# Site Accessibility Evaluation

## Americans with Disabilities Act Title II (Public Services: State and Local Government)

### Fair and Events Complex

**366 10th St  
Calhan, CO 80808**

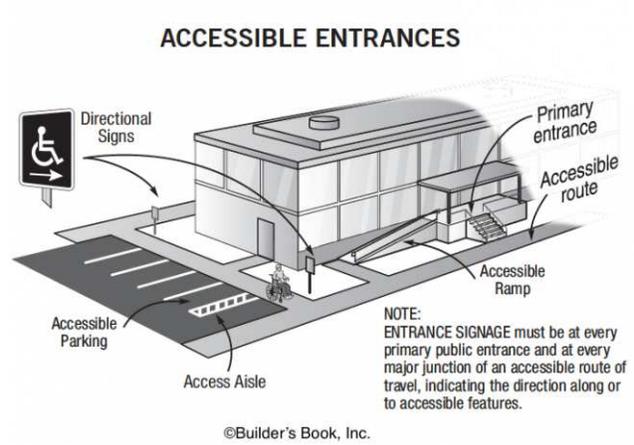
3.5 inches vertical change

Entrance not accessible to mobility devices due to the obstruction at the entrance. Recommend backfilling dirt/gravel to ensure a change in level no more than 1/4 of an inch or install an ADA ramp as used in school playgrounds or construct concrete ramp.
